Rezoning Transportation Analysis

Petition Number: 2024-018

General Location Identifier: 03149117, 03149118

Date	Description
03-27-24	First Review (KC)

1. Curblines:

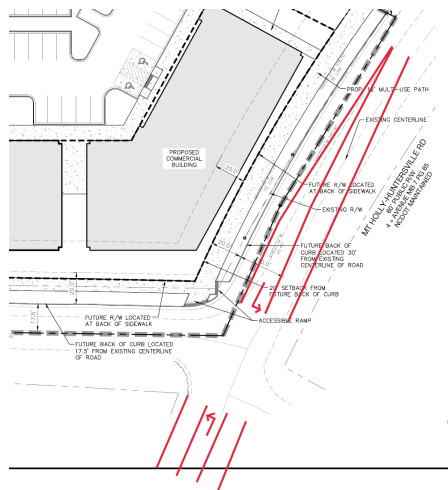
- a. **Mt Holly-Huntersville Rd:** The future location of curb and gutter is 30' from centerline.

4+ Avenue, Shared Use Path per the Charlotte Streets Map

- b. **Harwood Lane:** The future location of curb and gutter is 17.5' from centerline.

CLDSM standard Local Collector Street U-07B

Label and dimension the curb and gutter from the centerline for each road on the site plan. Show proposed striping layout for Mt Holly-Huntersville Road and commit to restriping for left turn lane on Mt Holly-Huntersville Road at Harwood Lane.
